STAFF REPORT: MARCH 12, 2025 REGULAR MEETING PREPARED BY: T. BOSCARINO

APPLICATION NUMBER: HDC2025-00052

ADDRESS: 4236 LESLIE

SCOPE: REPLACE WOOD SIDING AND TRIM WITH VINYL AND ALUMINUM

Image from page 5 of the application.

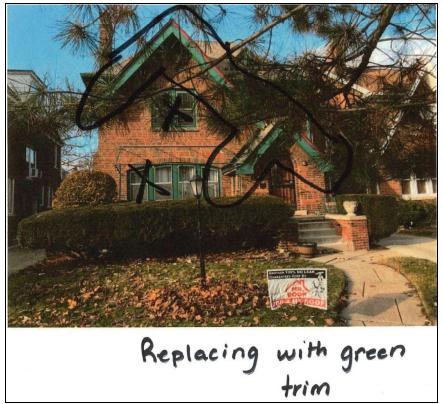
The soffits and fascia would be replaced on the front (south) and the east and west sides of the house. A sketch on page 5 of the application indicates that this would also include replacement of the historic vergeboards on the front of the house.

- The existing vergeboards are a highly distinctive feature that are particularly important to the character of the building. Removing these elements would greatly compromise the building's historic appearance. Even if the vergeboards were substantially deteriorated, the Standards would require that they be replaced with new work of the same dimensions, design, and materials. (See Standard #5, quoted below.)

- The historic vergeboards are highly distinctive elements, important to the building's overall appearance and character. Their removal would eliminate a distinctive feature, contrary to Standard #5.
